## Comments from 4/12 - Draft Responses

### Water Quality Comments

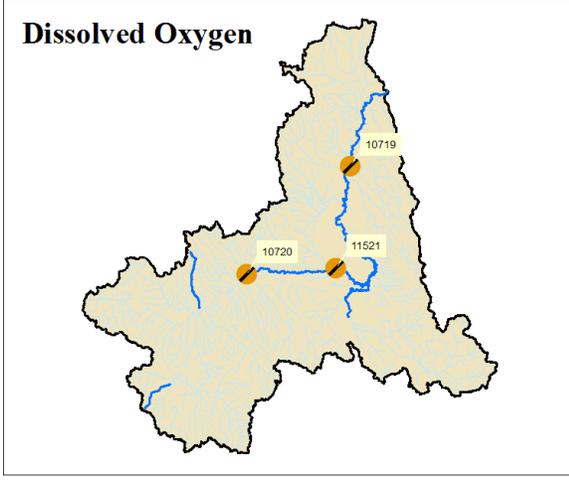
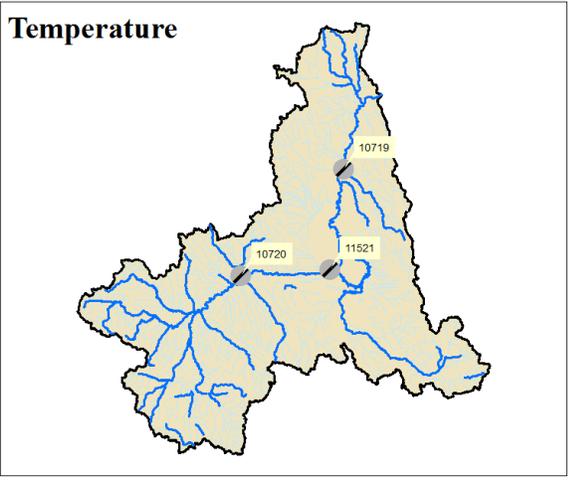
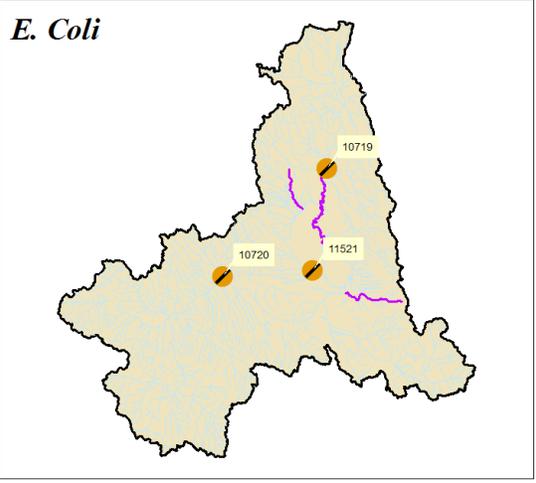
- **Comment: Provide 303(d) water quality information on a map**

Response: The following information is currently included in the report (could make multiple figures showing each different parameter, like the figure from DEQ report below)

**Limits to Beneficial Use**

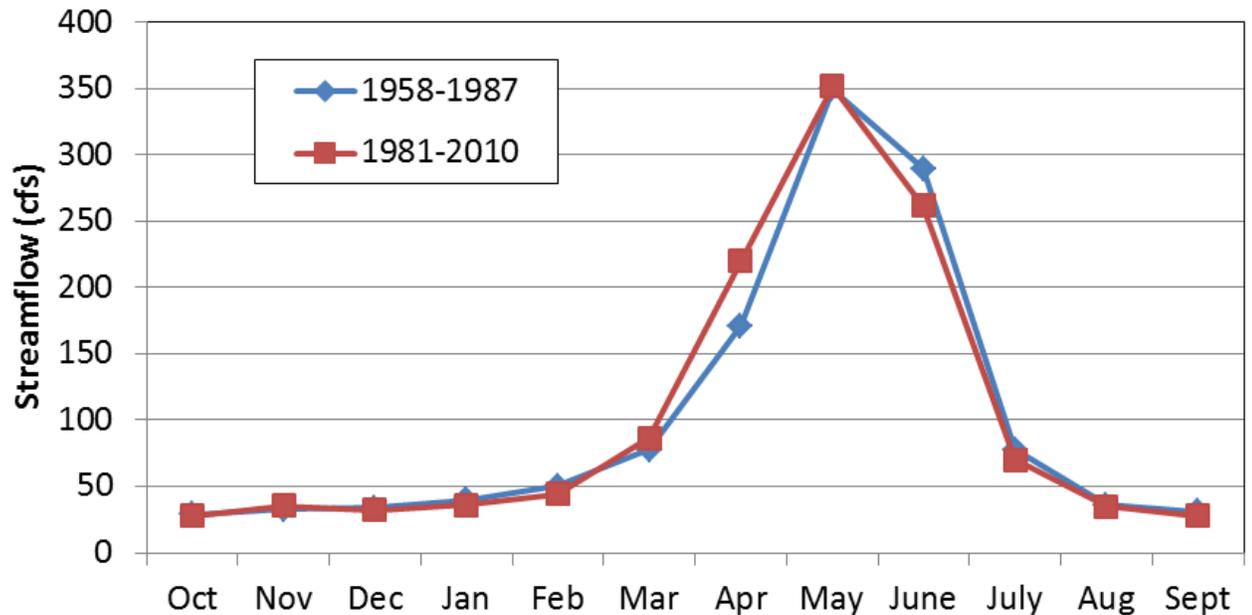
- Comment: Most of the beneficial use data criteria seems focused on fish (what are standards for other listed uses such as boating?) Maybe only include the uses for which there are criteria. Flow should potentially be removed from the chart. Chart seems limited.**

Response: See revised charts, example below. The charts focus on the most restrictive criteria for beneficial use, which is aquatic life use. The charts show other uses when the information is available. Agree?

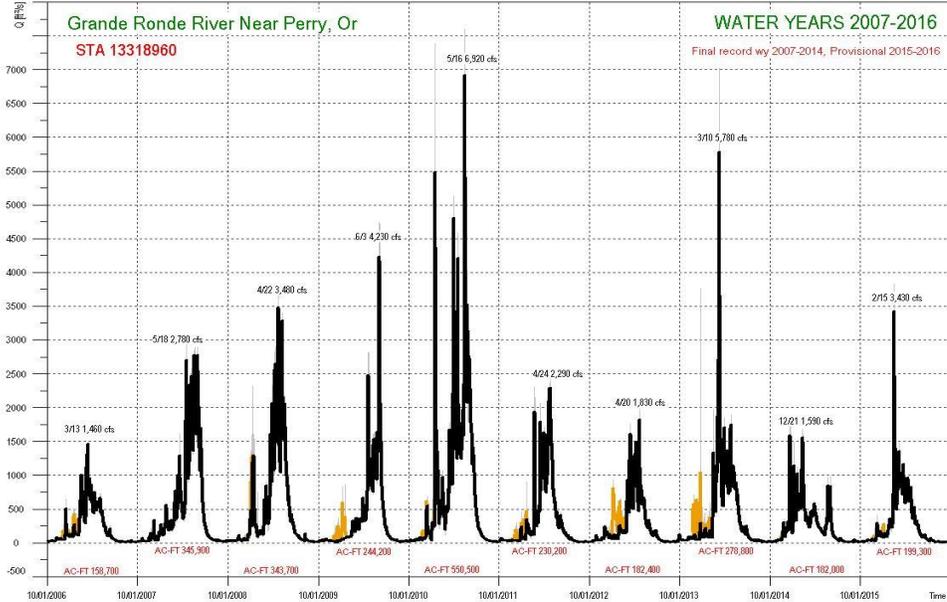
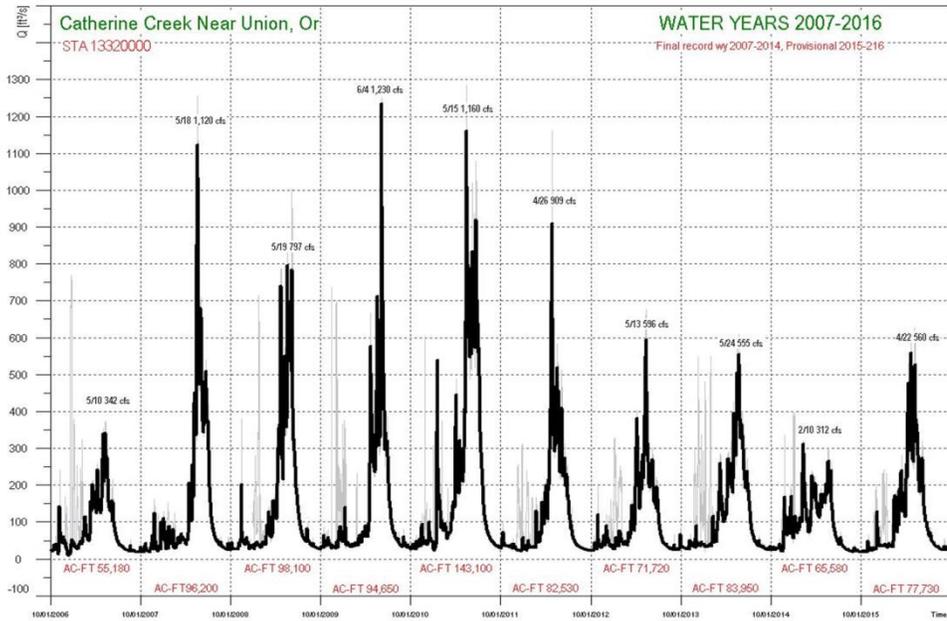
- Comment:** Consider just showing gauged data (without consumptive use added in).  
Response: These are two graphs of gauged data for Catherine Creek and UGR. We have data like this from about 3 other gauges. We can include this in the report, do we want the other ones? We have gauged data, but it does not serve our ultimate purpose to complete the water balance. We would recommend not showing this information, because it seems like it would add confusion to the report. Thoughts?

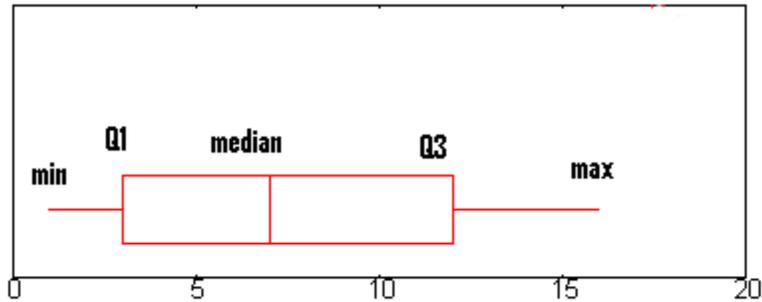
- **Comment: Why did we use medians and not means for flow? Add in average, box and whiskers plots with median and means for more information**

Response: We used exceedances of the median. We could work with OWRD to make these box plots. We have not moved forward with this yet, we should decide as a technical committee.

(From OWRD) Typically the median (50% exceedance) annual volume is less than the mean annual value, in some cases 10-20% less. Using the mean would overestimate the amount of water that would normally be available for use in any given year.

This information is generally shown in the graphs – we could discuss alternate methods for showing this data. **Do we want to show flow in this type of format?**

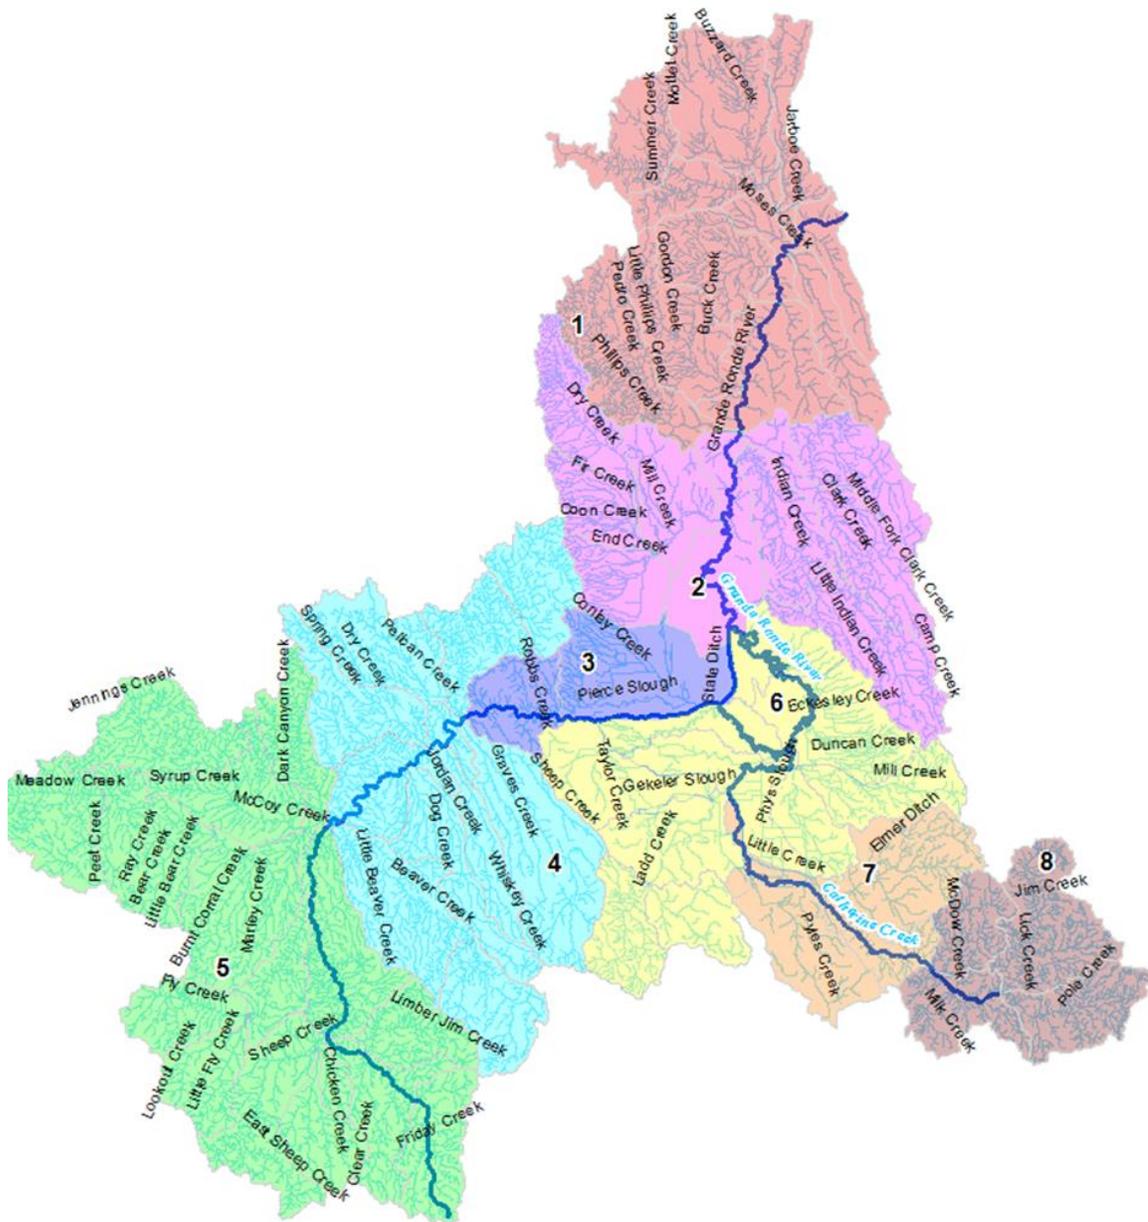
- **Comment:** The old river channel is shown on the map – we need to label it as the old channel to avoid confusion Include more land marks on the large map – label tributaries
- Response: Map is being revised. Review base map below:

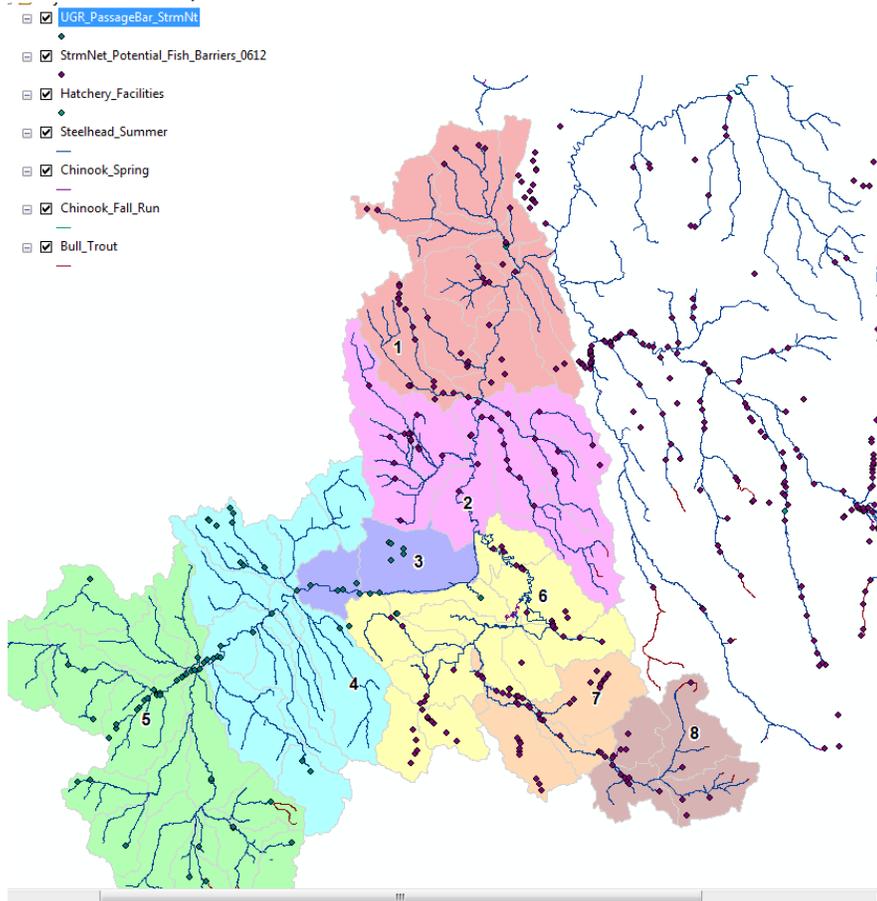
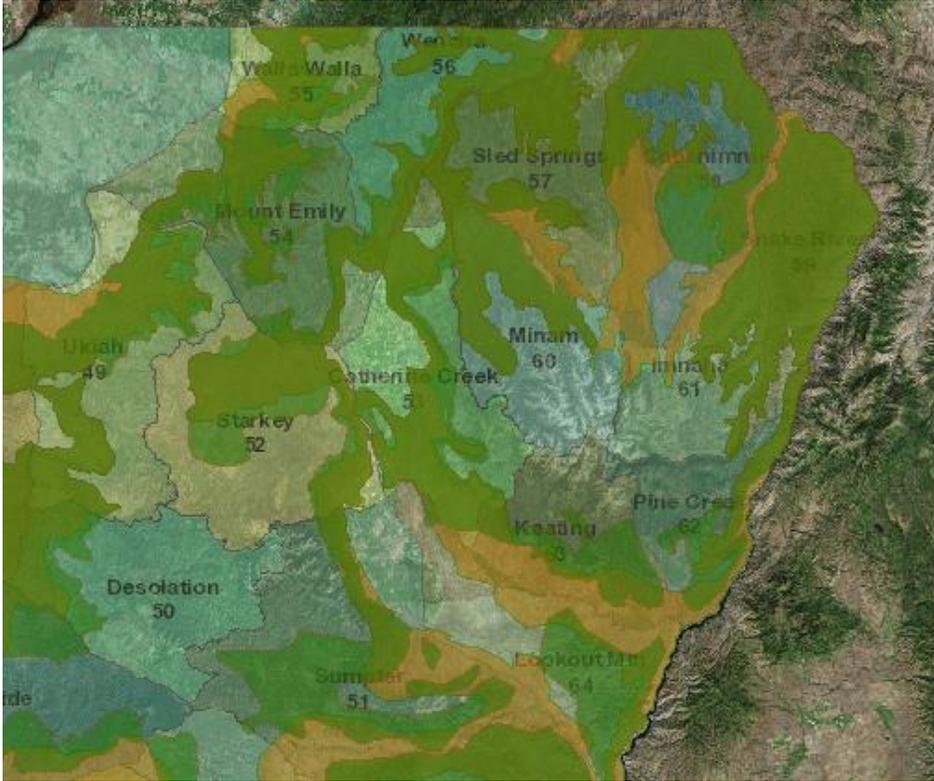
- **Comment: Basin 8 & 5 are likely affected by terrain**

Response: This description was added to report.

The UGR includes both winter deer (yellow) and elk (green) habitat

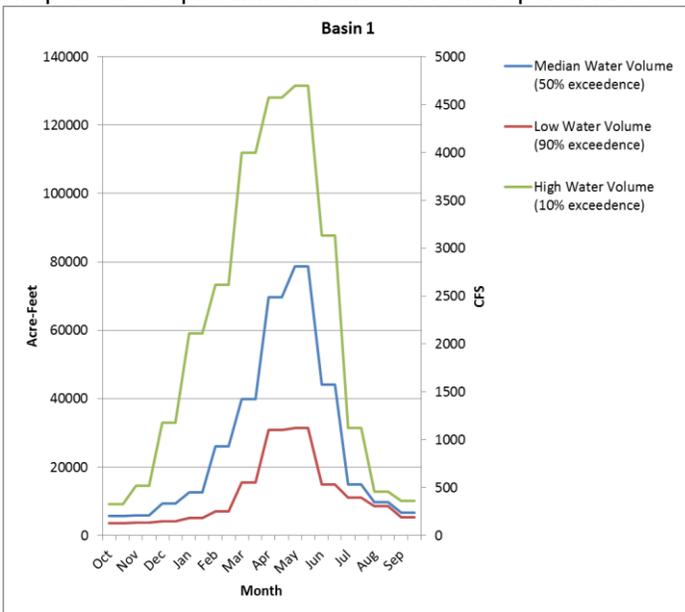
- **Comment: Use Atlas for biological characteristics**

Response: ATLAS and COMPASS will be used, some graphics are included, **specific feedback is needed on which datasets would be helpful for this planning effort.** So far – planning to use ATLAS for fish species distribution and COMPASS for wildlife distribution

### Temperature Data Collection Sites

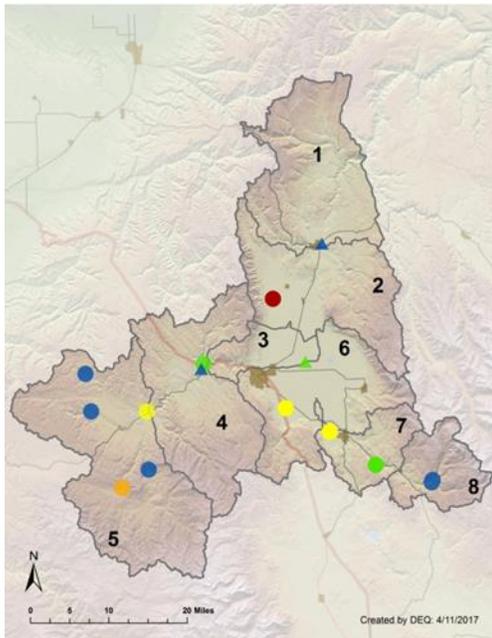
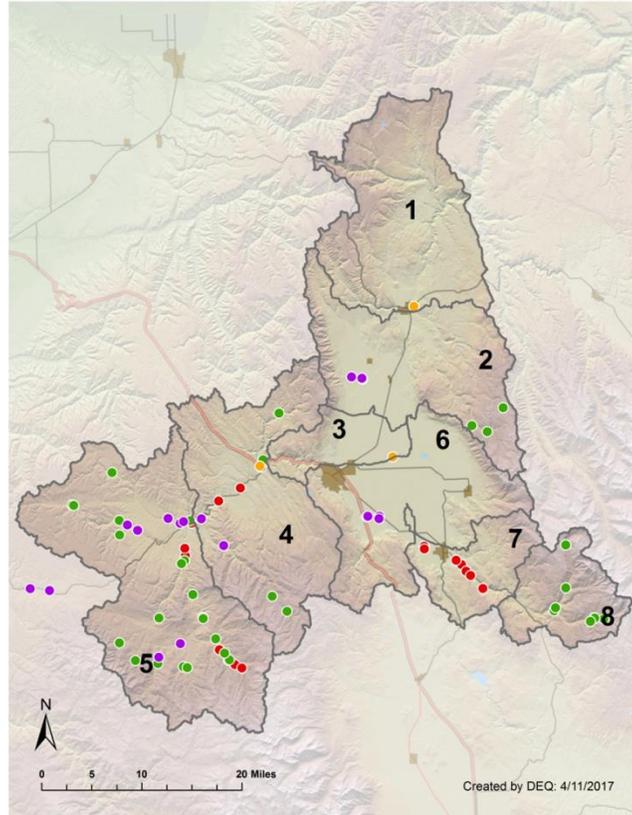
- **Comment: USFS has much more temperature data - use this to address data gaps**

Response: Data was used from the following areas and simplified the map by using a single dot to represent multiple sources. I think that we just didn't explain this clearly at the meeting and can work to clarify at the next stakeholder meeting. No additional work recommended here.

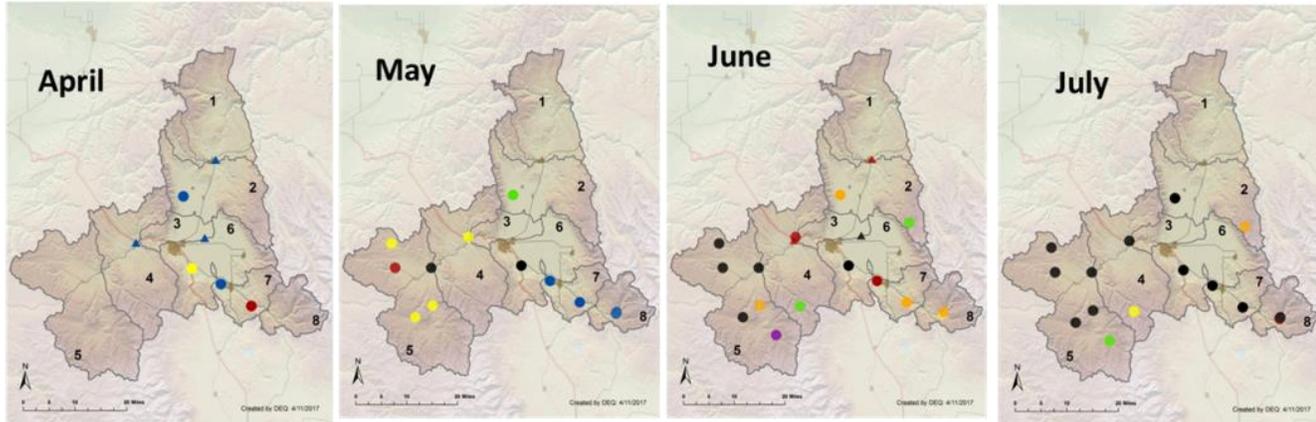
- **Comment: Temperature trends in bottom chart need to be explained**

Response: Unit measurements will be included in the report. Trends are that June-September most locations are temperature limited. October through May most locations are not temperature limited.
